TOWN OF POMFRET
Selectboard

Memorandum of Decision

Property Address: 19 Dinsmoor Road
Pomfret, Vermont

Revised Site Plan

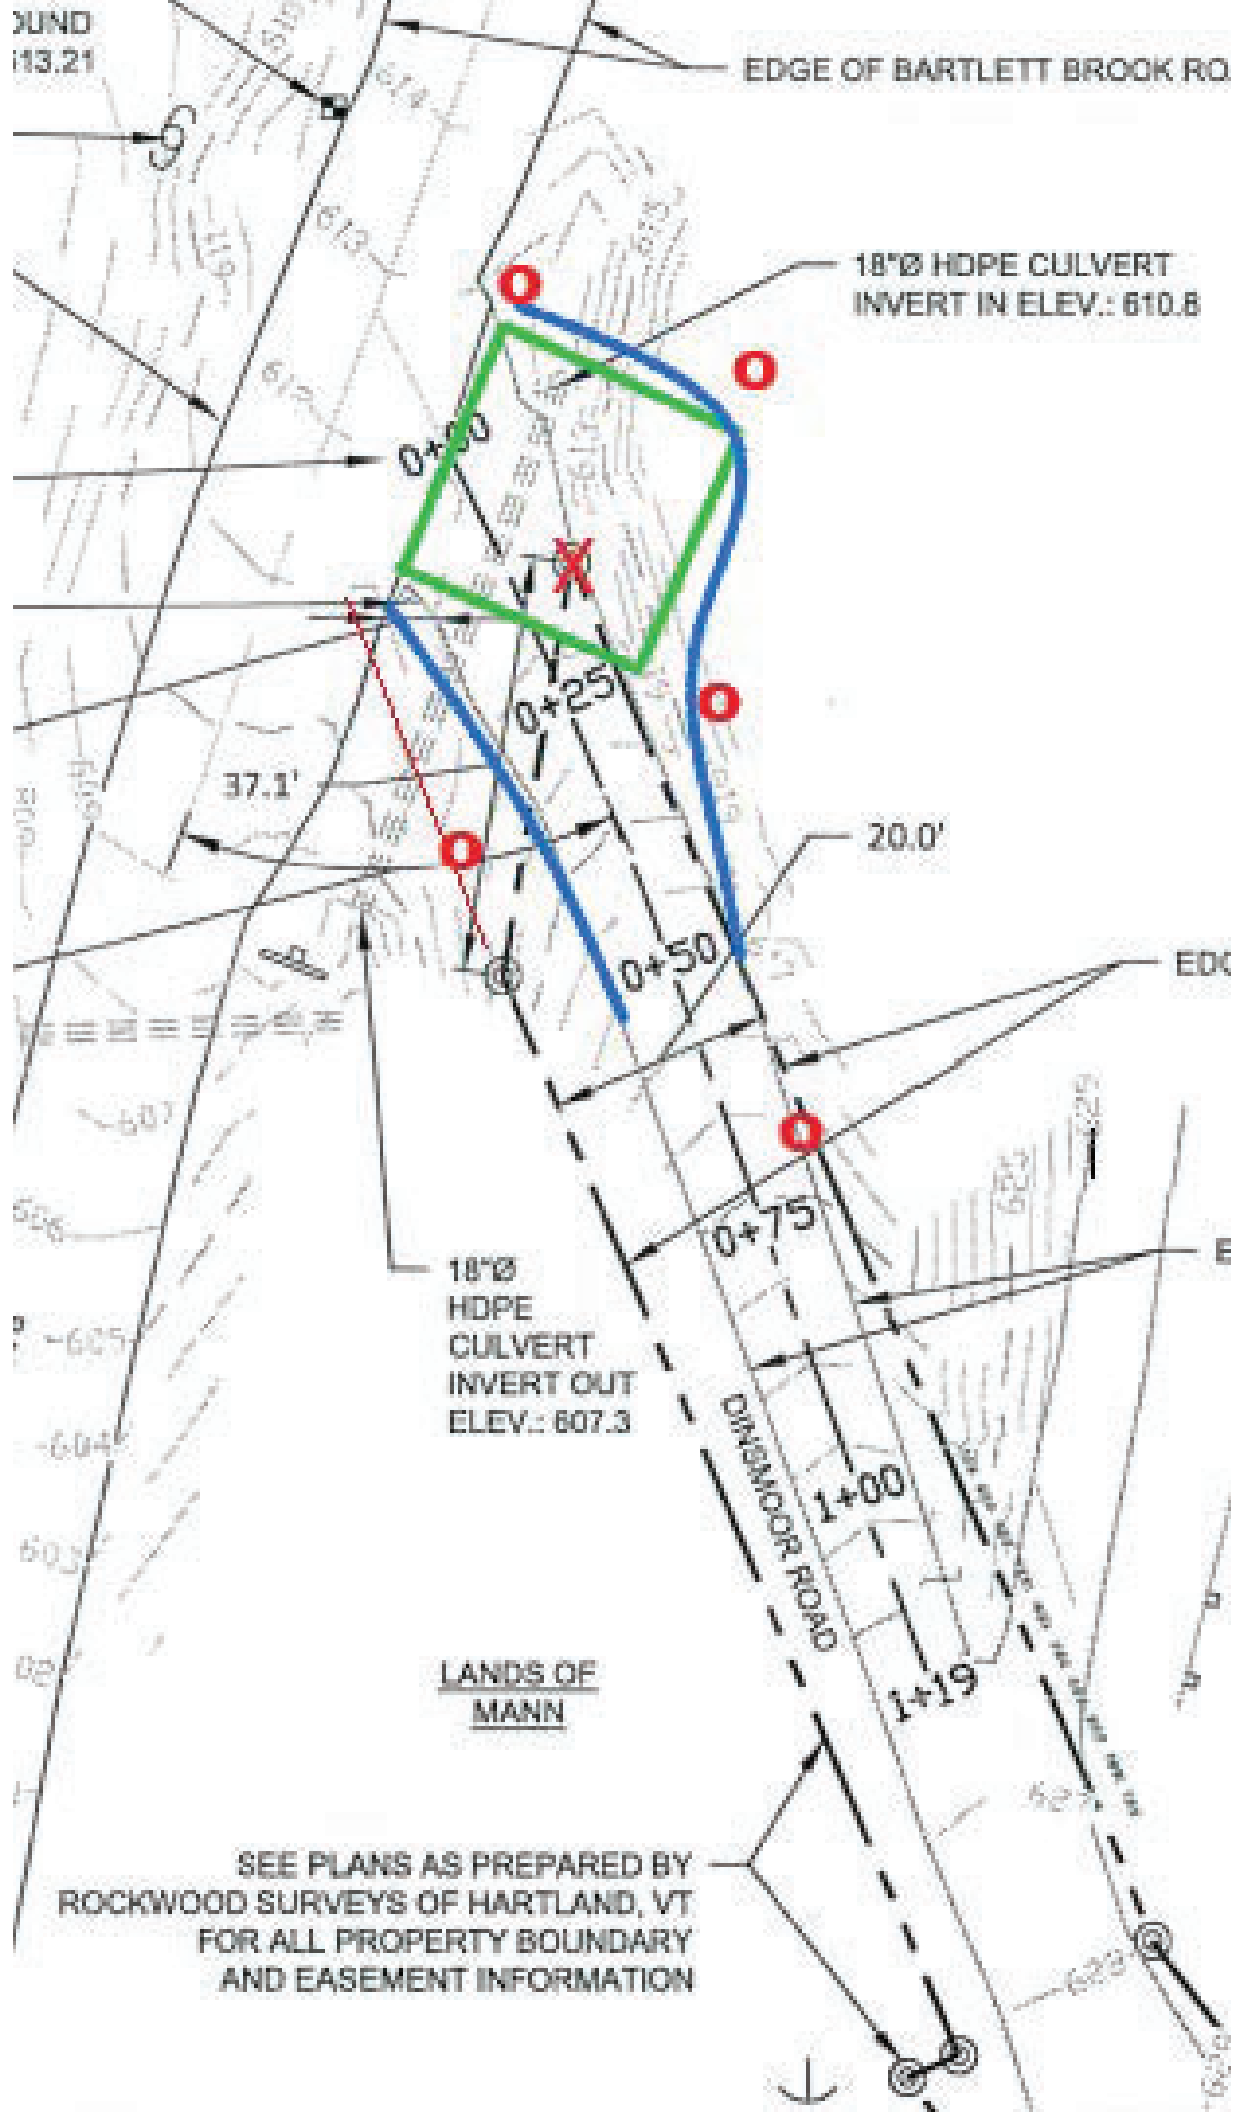
Mr. Mann’s Permit Application indicates that he proposes to construct a “[w]idth of driveway between 17’ and 19’”. “Driveway will enter town road at 90 degrees and pitch away from the town road 1’ over the first 20’ from the town road.” “See green rectangle on sketch.” Condition and Limitation B states that “[t]he first 20 feet of the driveway shall conform in all material respects to the materials included in the Mann Application, Revised Site Plan, and testimony of the witnesses, except as modified herein.”

As set forth in Footnote 4 of the Memorandum of Decision, Mr. Mann chose to use altered CAD engineering drawings prepared by Ian MacKenzie for his Revised Site Plan and which were part of Dr. White’s and Mr. Dechert’s proposed driveway permit application. CAD drawings are not sketches. CAD drawings use actual units of measurement based on the existing topography and distances on the ground. Although ultimately rejected by the Select Board, Mr. MacKenzie testified as to how he created his drawings and what the lines in his site plan represented as to distance, elevation, slope, and the markers called out on the ground. Those same distances and slope exist in Mr. Mann’s Revised Site Plan to which he is bound per the Memorandum of Decision and Conditions of Limitation.

Attached as Slide 1 and Slide 2 to this request for reconsideration are CAD drawings prepared by Mr. MacKenzie. In Slide 1 Mr. MacKenzie has overlaid Mr. Mann’s Revised Site Plan onto a CAD drawing that mirrors the lines and circles Mr. Mann drew and submitted as part of his Revised Site Plan. By way of comparison, Slide 2 is the actual CAD drawing calling out Mr. Mann’s lines (and the distances he drew for the driveway area). Mr. Mann testified (13:42) that the blue lines in his Revised Site Plan represented the edges of his proposed (and approved) travel way on Dinsmoor Road. Given that testimony, and given what he submitted as a Revised Site Plan, those CAD drawings demonstrate that Mr. Mann’s Revised Site Plan actually contemplates an almost square box that is 23.1’ in width along Bartlett Brook Road and 23.4 feet deep.

3. Driveway Area Dimensions. The Selectboard understood the proposed modifications to include “a level graded, 20-foot wide by 16-foot deep area in which vehicles may enter onto and exit from Bartlett Brook Road.” See Section I.B of the Mann Decision. Any discrepancy revealed by overlaying the Revised Site Plan onto more precise CAD drawings should be resolved in favor of the Applicable Standards described in Sections III.A and III.B of the Mann Decision.

PROJECT TITLE:	SHARED ACCESS ENTRANCE TO BARTLETT BROOK
SHEET TITLE:	EXISTING CENTERLINE PROFILE
PROJECT NO.:	2304
SHEET NO.:	C1.10
DATE:	6-12-23

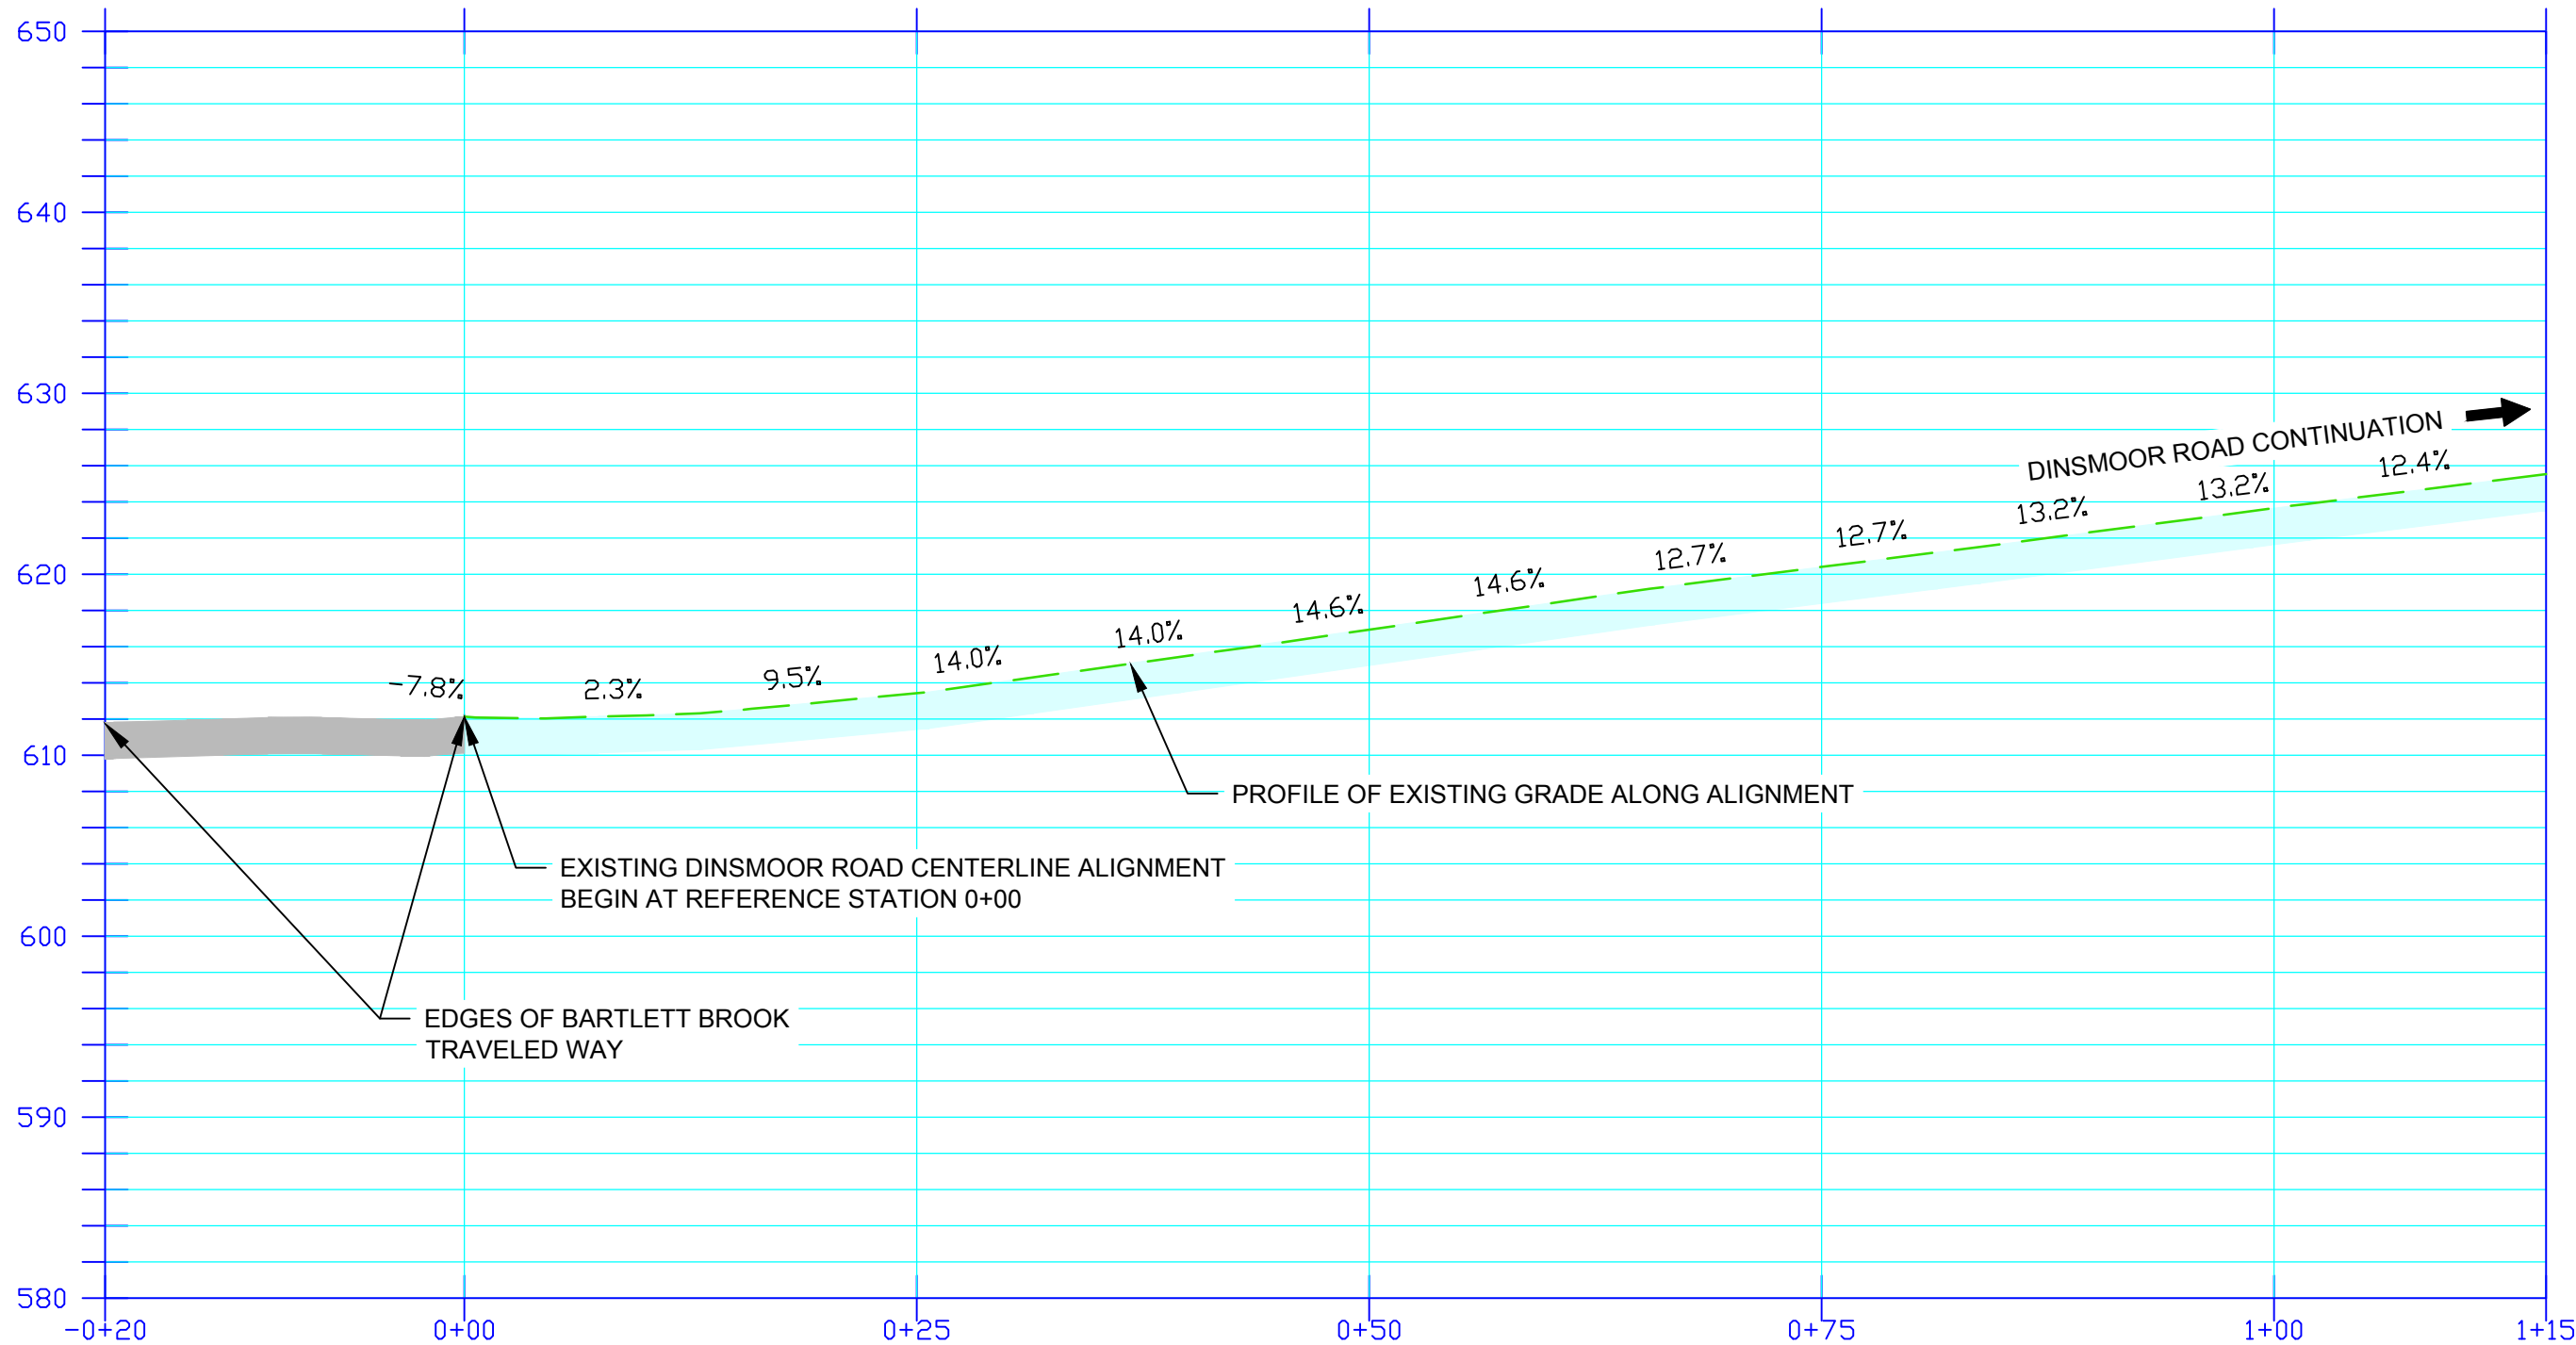
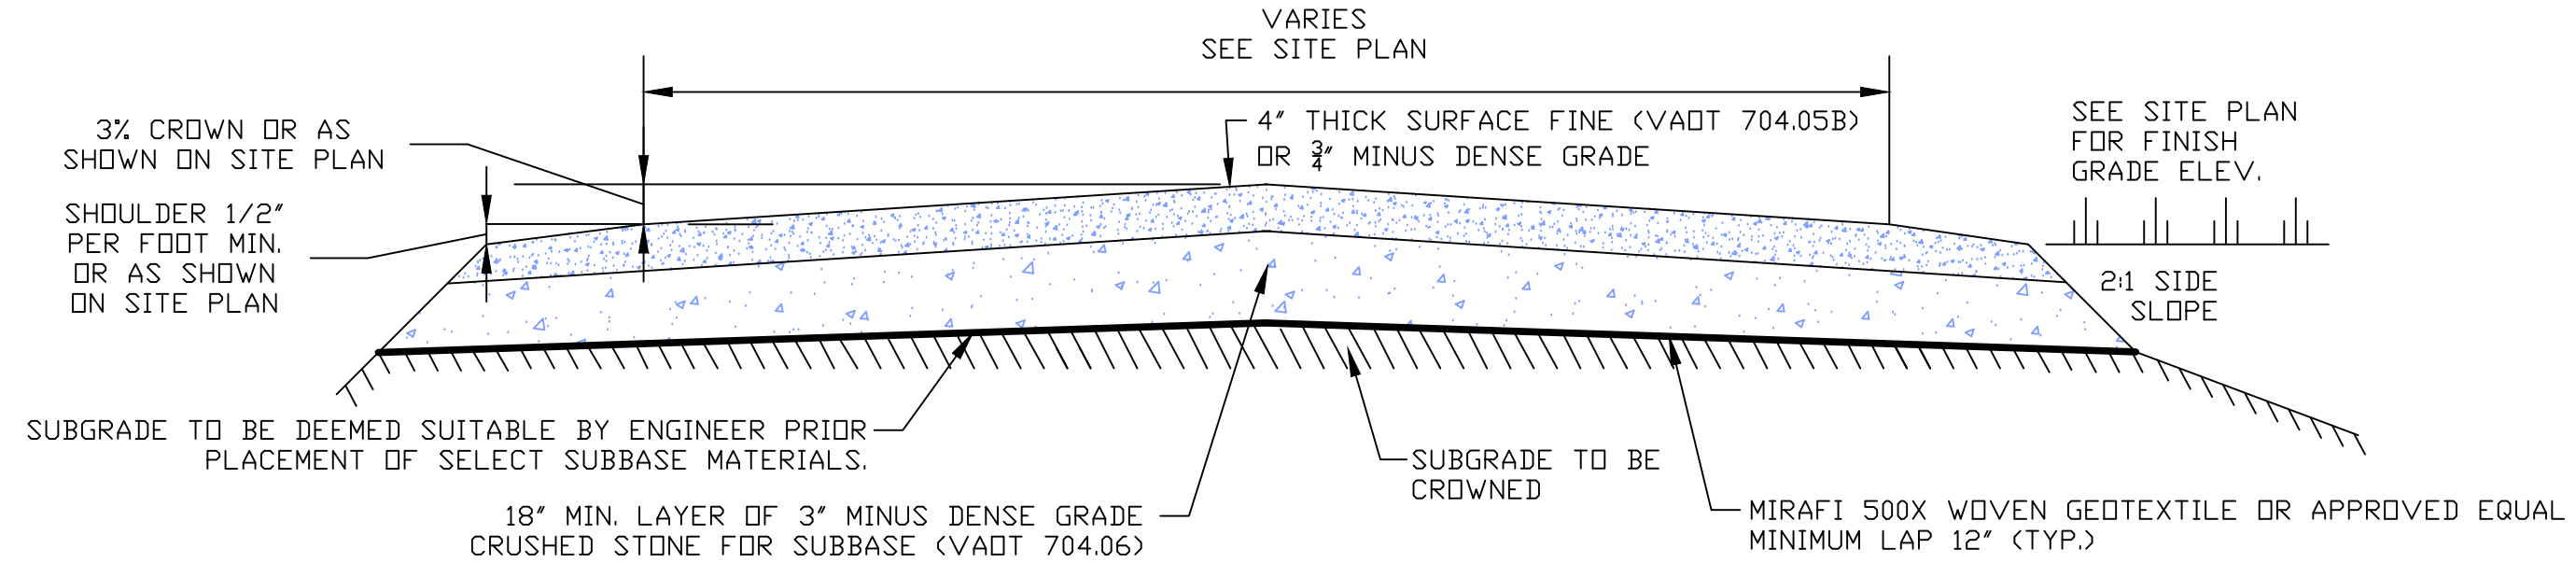
² *Compare* Sheet C1.10 with Sheet C2.10 in the MacKenzie Engineering and Construction plans attached hereto as Exhibit B (the “Construction Plans”).
